CORPORATE REPORT

SUBJECT: Revised Design for Phase I of the Guildford Town Centre Mall

Redevelopment - Development Application No. 7906-0413-00

RE: Engineering Requirements (Commercial)
Location: 1250 Guildford Town Centre

Road Right-of-Way Requirements Sketch

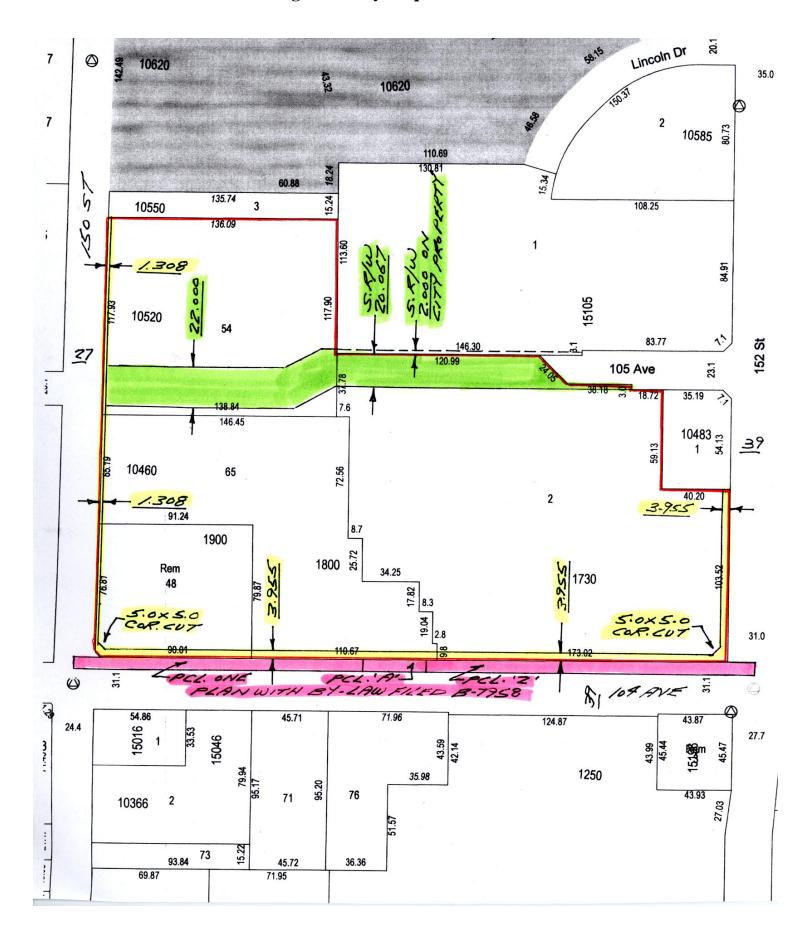
The following road right-of-way dedications, as illustrated on the Road Right-of-Way Requirements sketch attached, are required on existing roads fronting the site:

- 3.955 metres for a 39-metre wide road right-of-way on 104 Avenue;
- 3.955 metres for a 39-metre wide road right-of-way on 152 Street;
- 1.308 metres for a 27-metre wide road right-of-way on 150 Street to the north property line of the site;

- 5-metre x 5-metre corner cuts at the intersections of 104 Avenue/150 Street and 104 Avenue/152 Street; and
- The applicant is indicating the use of City land (10550 150 Street) for a drive aisle in conjunction with the proposed expansion of the parking lot (separate DP Application to be made to the Planning Department). The Engineeering Department supports this request subject to the applicant entering into an appropriate licence agreement with the Realty Division (604-598-5700), the provision of a 22-metre wide statutory right-of-way for the westerly extension of 105 Avenue, and the appropriate road dedication on 150 Street and 152 Street for the ultimate divided arterial roads.

- 3.955 metres and 2.500 metres for a 39-metre wide road right-of-way on 104 Avenue;
- 7.308/3.955 metres for a 39-metre wide road right-of-way on 152 Street;
- 1.308 metres for a 27-metre wide road right-of-way on 150 Street;
- 5-metre x 5-metre corner cut at the intersection of 104 Avenue/150 Street; and
- 0.5-metre wide statutory right-of-way along the east side of 150 Street for sidewalk.
